UNITED STATES PATENT AND TRADEMARK OFFICE

APPLICATION NO.	FILING DATE	FIRST NAMED INVENTOR	ATTORNEY DOCKET NO.	CONFIRMATION NO.
10/782,226	02/19/2004	Kenneth E. Conley	129M-0187U	5219
37953	7590	08/23/2005		
MILLER, EVERMAN & BERNARD, PLLC 4701 HEDGEMORE DR., SUITE 2500 CHARLOTTE, NC 28209			EXAMINER MACK, RICKY LEVERN	
			ART UNIT	PAPER NUMBER
			2873	
DATE MAILED: 08/23/2005

Office Action Summary	Application No. 10/782,226	Applicant(s) CONLEY ET AL.	
	Examiner Ricky L. Mack	Art Unit 2873

DETAILED ACTION

FIG. 4

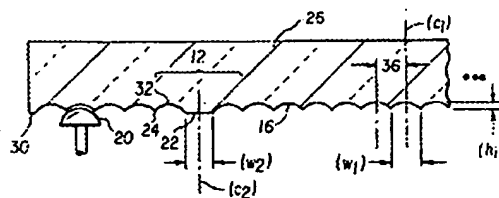
Young discloses, as in claims 2 and 14, the step of creating as cutting tool (20); engraving a plate or cylinder with cutting tool to form an inverse lens pattern in pre-selected areas (col. 4,

lines 9-23), using the engraved plate or cylinder in an extrusion embossment process such that the substrate can be embossed with the lens pattern (see figures 4 and 5 below).

Young discloses, as in claim 16, two different types of lens patterns (by virtue of quantity or lenses opposite space 22 in figure 4).
